LAMBCON ASSOCIATES

ASSESSMENT OF POTENTIAL VISUAL IMPACTS ARISING FROM REZONING OF LAND OFF SEASPRAY STREET, NARRAWALLEE

PRELIMINARY REPORT

FIG 1b SECTIONS THROUGH THE SITE

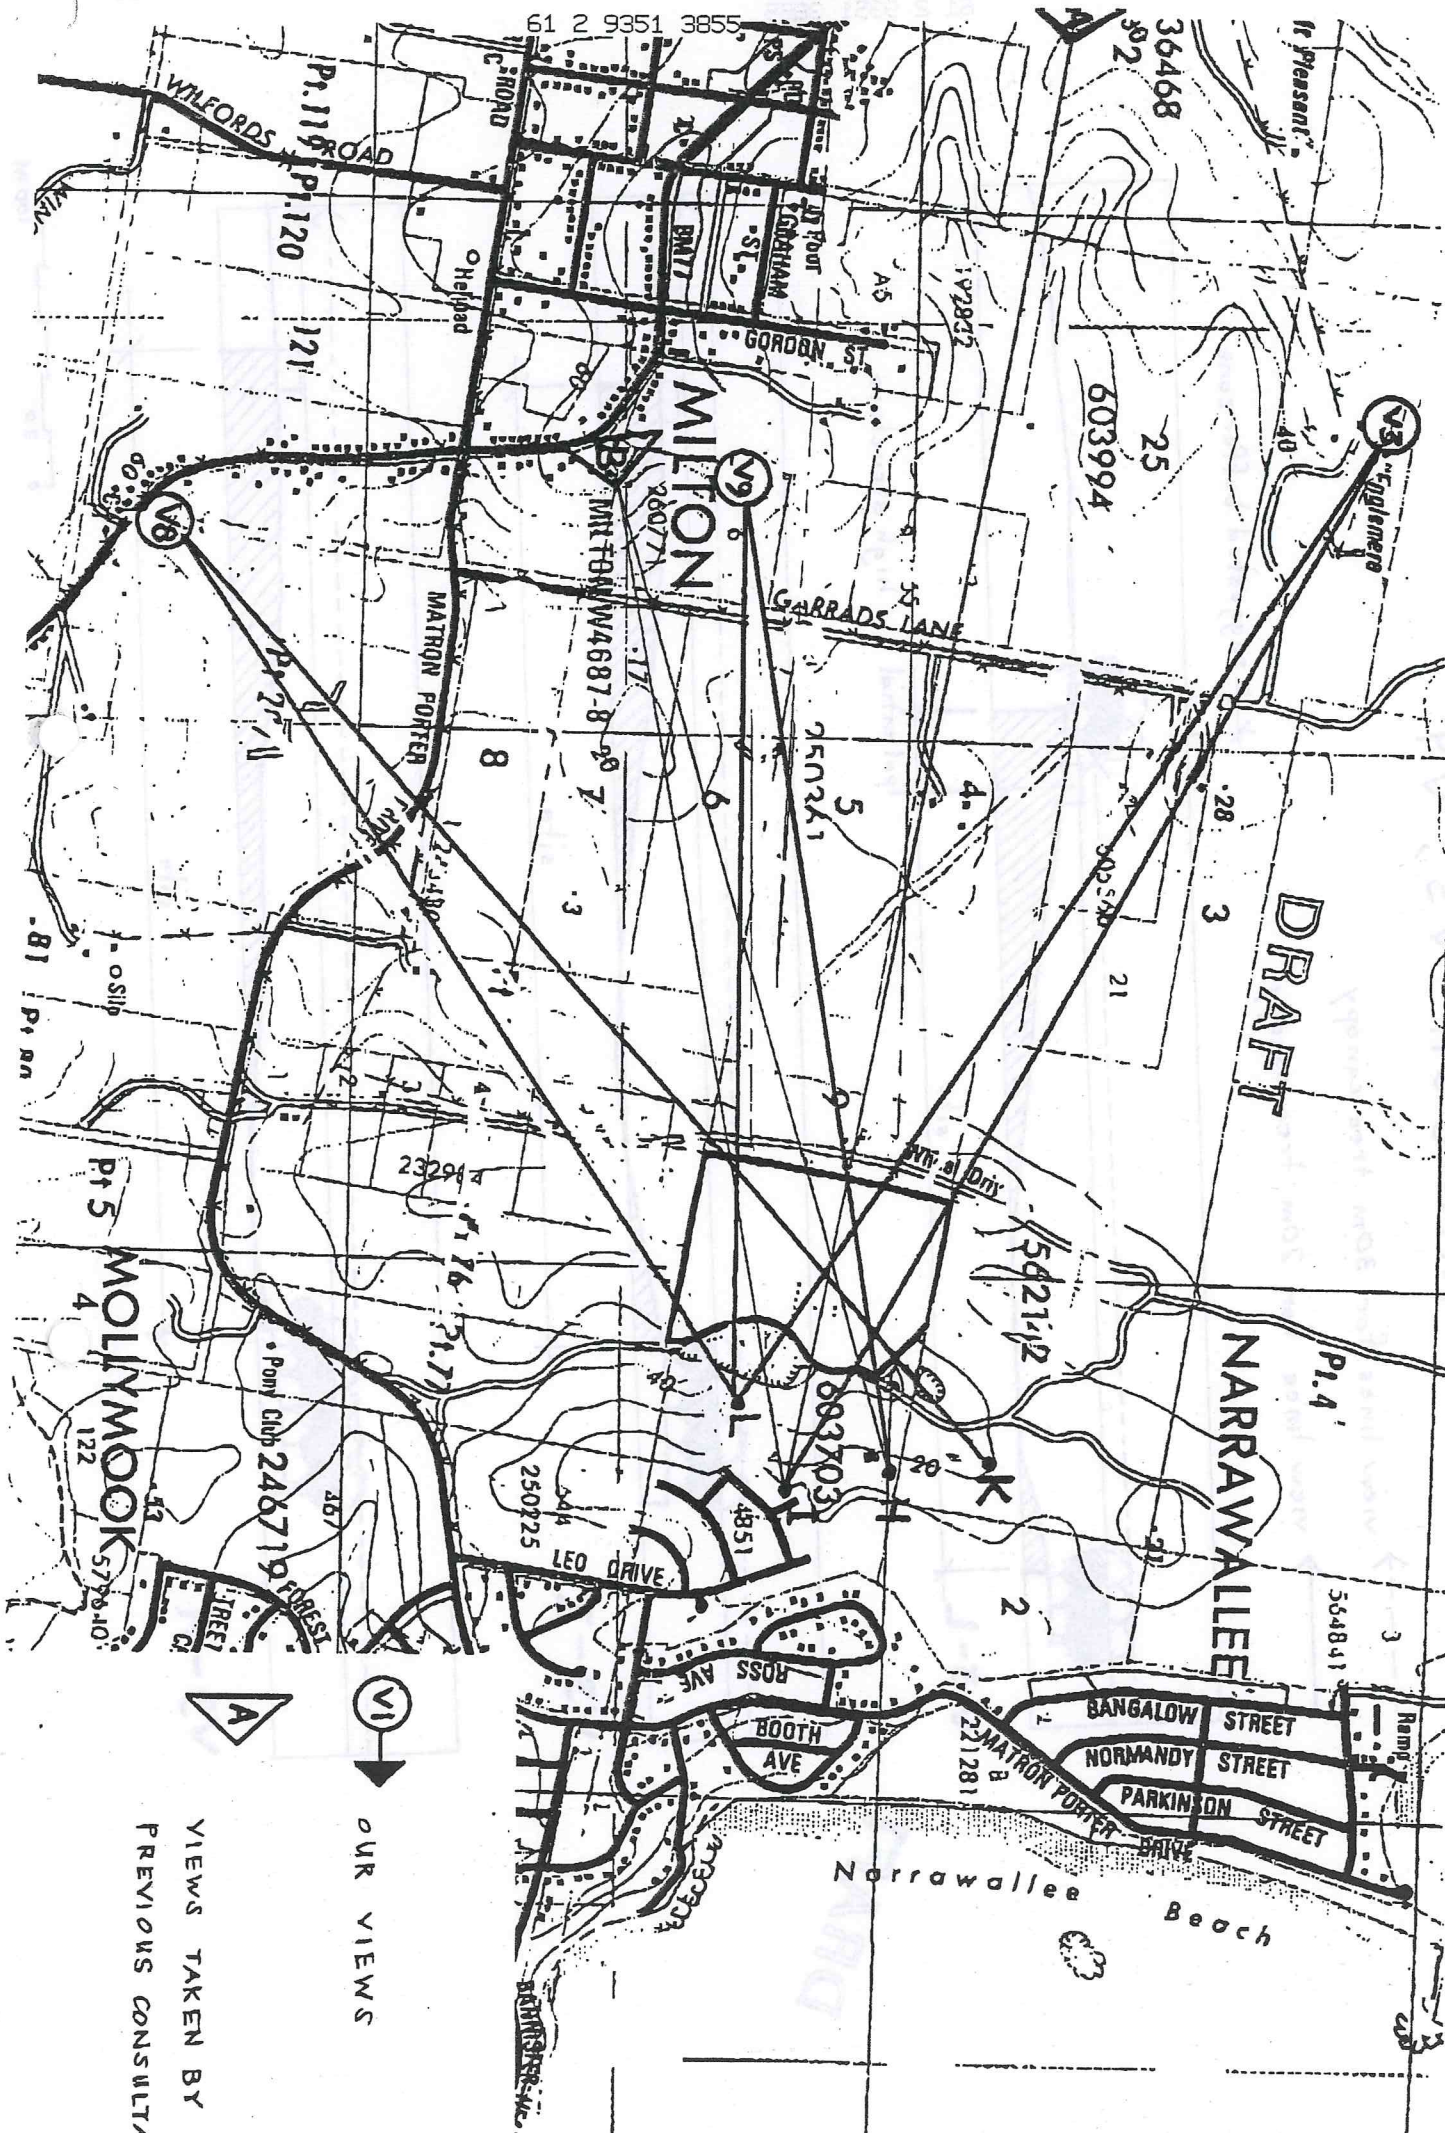
- Tree heights should be assessed on the part of the transects which pass through the site, from there to the following points, indicated on Figure 1b: Points L, I and H, ie. on section lines V9-L, V9-I, V9-H..

- Bands of trees in a line crossing the transect at right angles should be assessed. A sample of say 10-12 trees, that have crowns that are part of the general canopy surface, would be sufficient for each sample. Isolated taller trees should be ignored, or measured in addition to the sample. The samples should be taken to represent the canopy height at the highest point immediately west of the western boundary of the site (generally about 50m west of the western edge of the site), just inside the western boundary, the floor of the gully, a point 100m east of the gully floor sample, and the eastern margin of the site.

- The number of trees sampled can be decreased for the sample at the eastern margin of the site. Five trees, provided they appear to be representative of the general canopy surface height, would be sufficient.

- The accuracy of this work would be further improved if the RL of each sample place was established.

FIG 2a SECTIONS THROUGH V3, V9

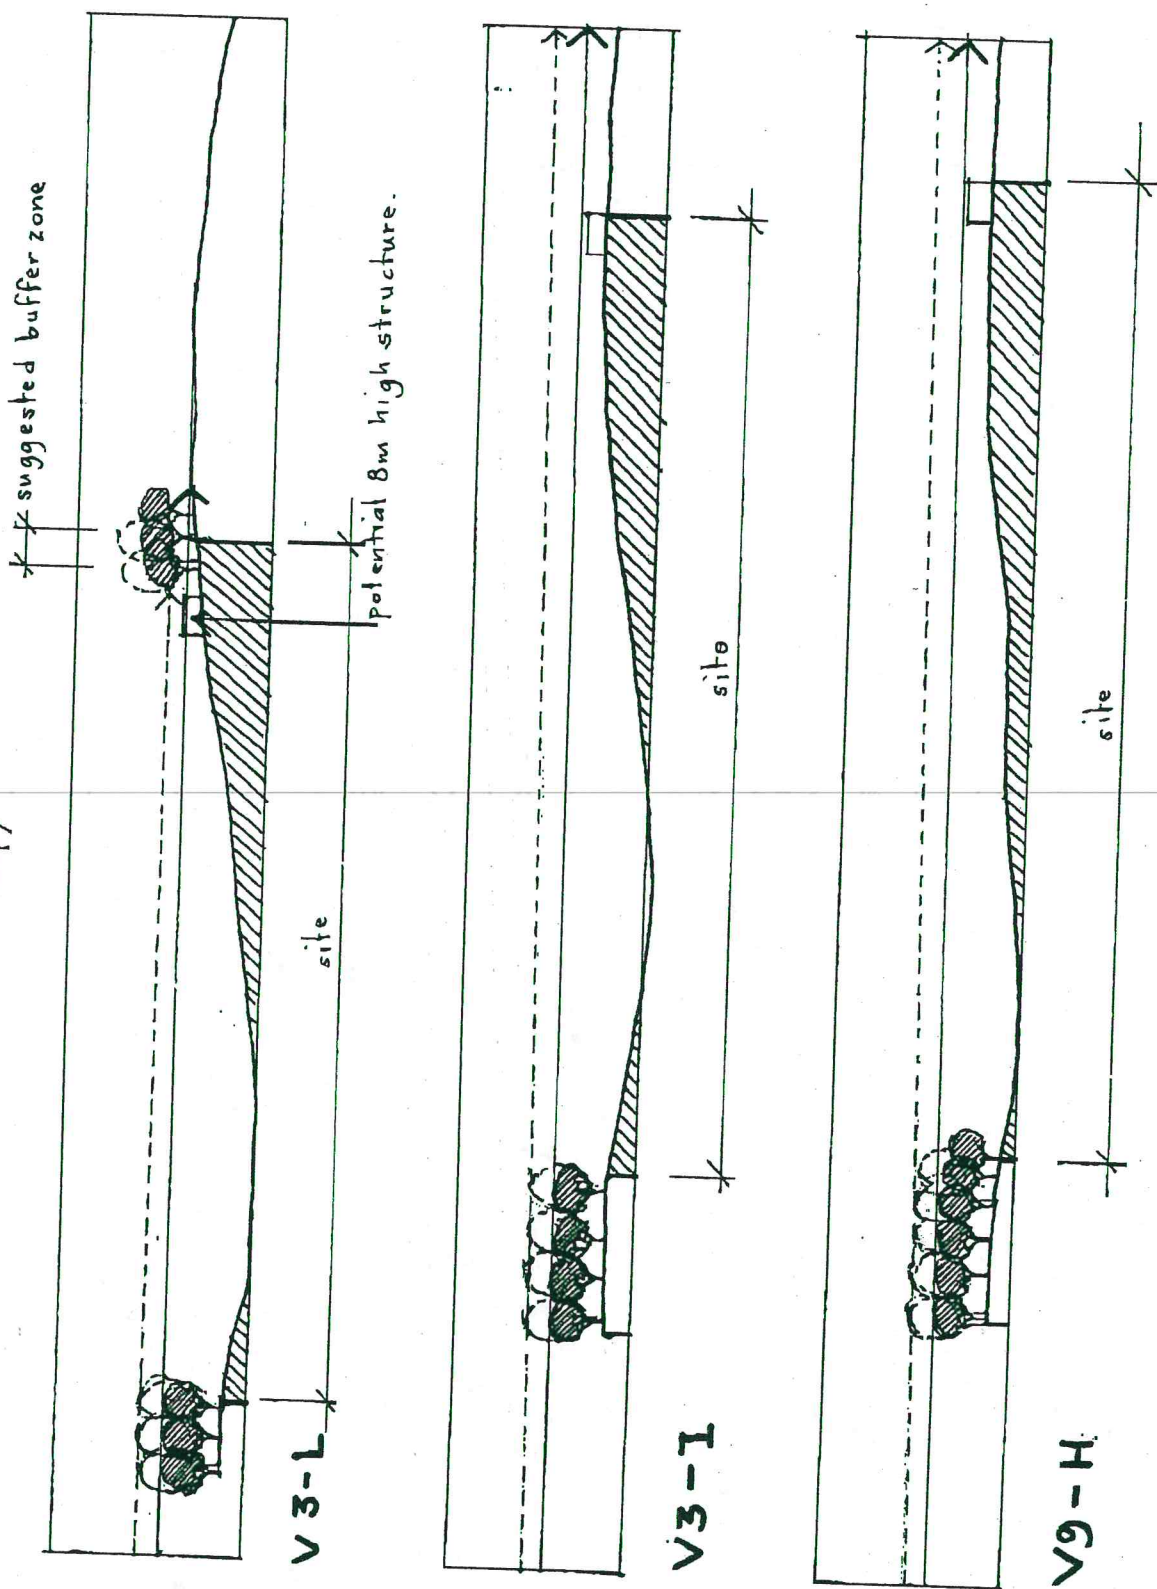
- These sections indicate that views from the eastern fringe of Milton and the rural landscape at similar elevations in the vicinity would experience some visual impacts of the clearing of the site (ie. from viewing places V9 and V3 shown on Figure 1b).

- The sections relevant to these view lines are shown on Figure 2a. The lines were drawn to the same terminus points used in the assessment carried out for the applicant previously.

- Briefly, it can be seen in Section V3-L and V3-I that an 8m high structure would be either visible or very near visible assuming 20m canopy height. Structures above that height would be visible on both view lines.

- Section V9-H again indicates that an 8m high structure would be barely out of view, whereas V9-L indicates that such a structure would be visible.
- Each of the sections also indicates that, even if structures were not visible, the view line intersects the canopy of trees below their mid-level, or lower. In this case, a hard edge would be produced by clearing, which would be highly visible because of the shadow line caused, by colour and texture contrasts and by the exposure of branches and trunks to view, particularly in afternoon light.

- Some of the latter effects would exist for the clearing scenarios suggested, even if the tree canopy is generally of 30m in height.
- In the event that the canopy height is less than 30m, the effect would be greater. In the case of V9-L it can be seen that the view line would intersect either the bare ground, understorey, or the lower canopy, depending on where the canopy height fell in the range of 20-30m.

FIG 2b SECTIONS THROUGH V8, V9

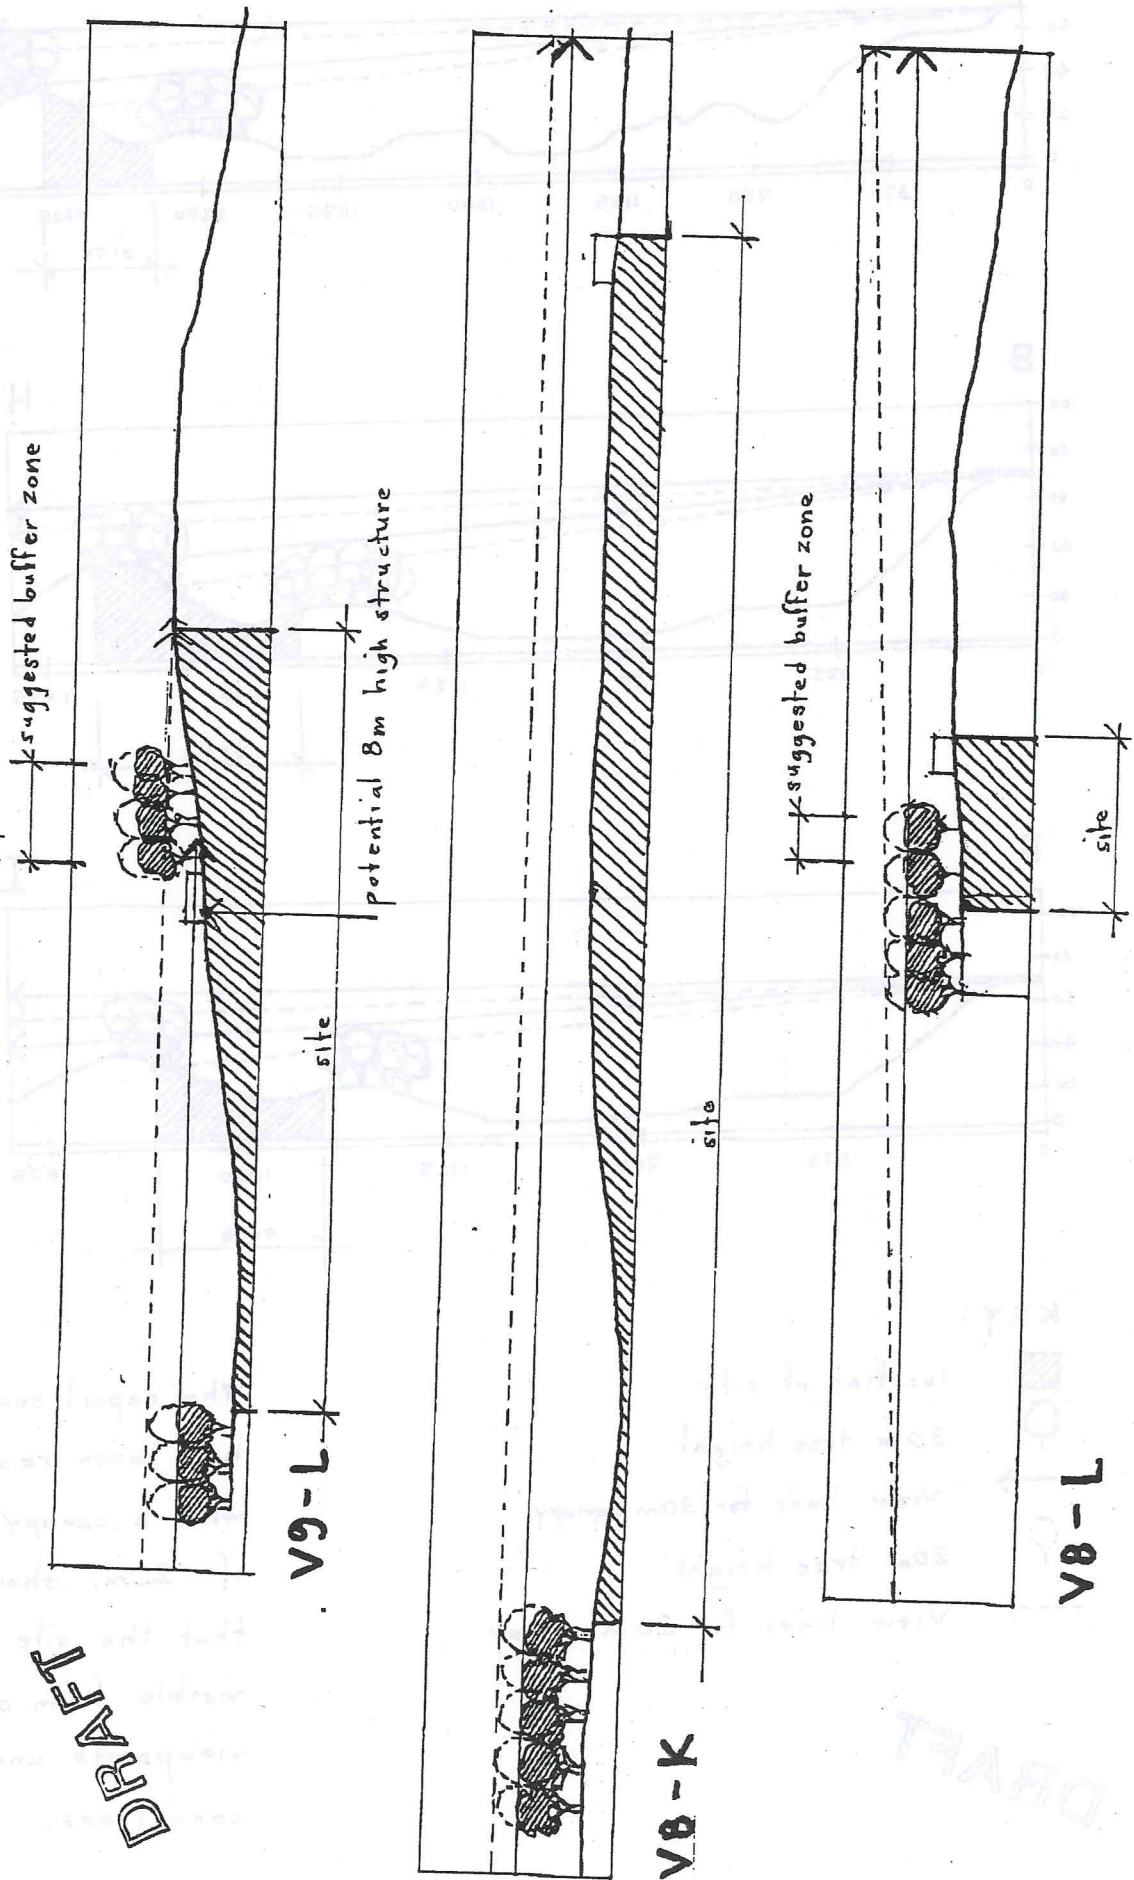
- Sections relating to Viewing Point 8 (V8-K and V8-L) indicate that the clearing of the site would not be visible. This principle applies to several of the view points used by us and the Applicant's consultant.

FIG 3 ANALYSIS OF ORIGINAL SECTIONS

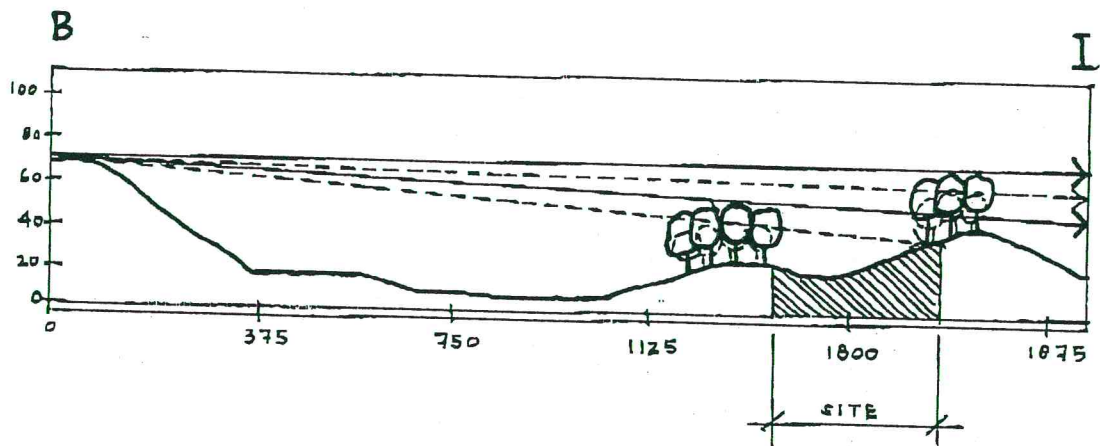
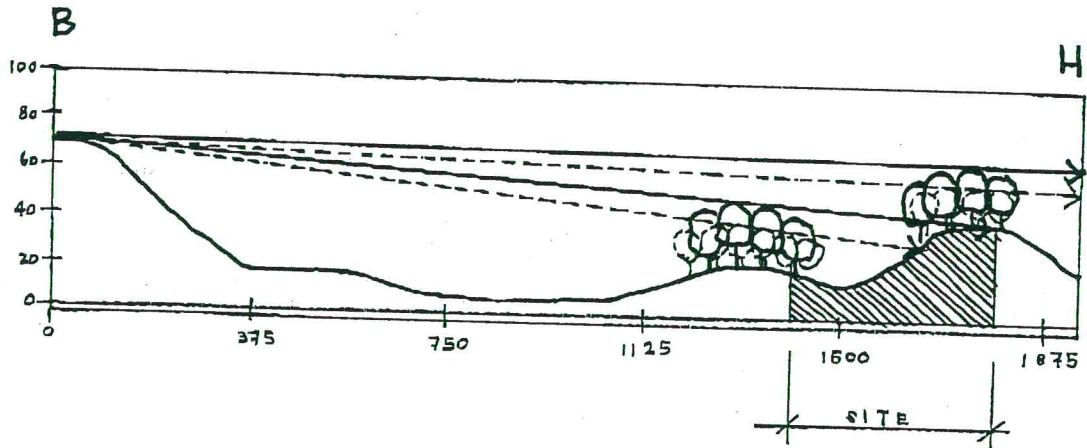
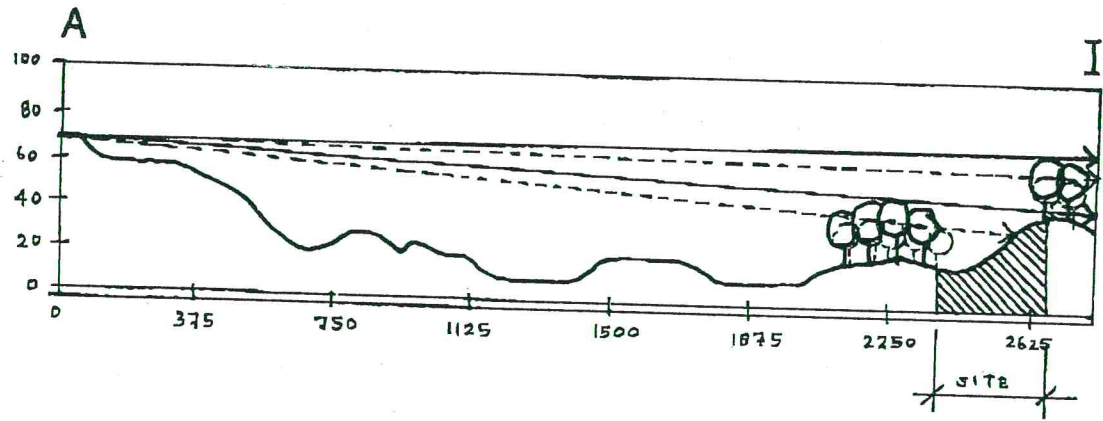
- We compared our observations and the conclusions which arise from these, and also our view line sections, with those of the Applicant's consultants.
- We more accurately re-drew some of the sections from the report, where we considered that the view shown may in fact experience greater impacts than were indicated.

- We also re-drew these sections, including estimation of a lesser average tree height, ie. 20m rather than the 30m adopted in the report. Some of the sections from that report are re-drawn as Figure 3.

- It can be seen by inspection of Sections A-I, B-H and B-I, which include the location of the site more accurately represented than in the original report, that if the canopy is less than the 30m estimated, there are site lines which would experience impacts. For example, section B-H would exhibit the hard canopy edge and clearing effect discussed above, even if the canopy was a minimum 30m in height. If the canopy were nearer 20m, the sight line would intersect with the ground and structures and clearing would be evident. This is confirmed in our sections from the nearby view point at a similar elevation, View Point 9.

The report sections have been redrawn with a canopy height of 20m, showing that the site may be visible from some viewpoints under these conditions.

FIG. 5a SCENARIO MAPS

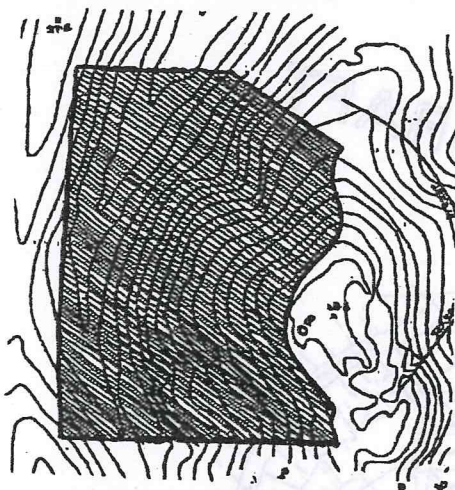
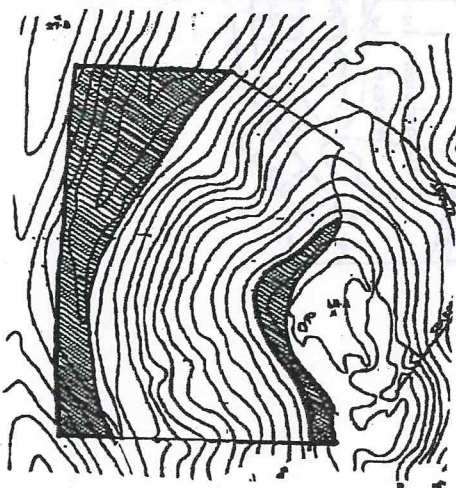
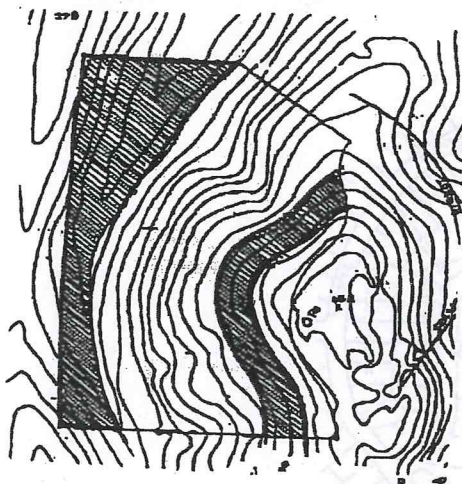
- We also assessed the likely visual effects of the three clearing scenarios which were suggested in the report, in the light of our findings. This analysis is shown in draft plan form in Figures 5a and 5b.

- Our evidence is that there would be visual impact effects, contrary to the report's findings of there being none.
- In assessing the scenarios of clearing in the report we became aware that Scenario 3, which would involve clearing to the 43m contour, would have the effect of clearing right to the ridge crest in the north eastern part of the site. It cannot be stated categorically in the absence of data on tree height on the view line as to whether this would expose development to view.

- The down slope extent of the effect of Scenario 2 is less clear and would depend on more accurate data on tree heights. Some of the site and buildings on it are likely to be visible, in the north east and east centre of the site.
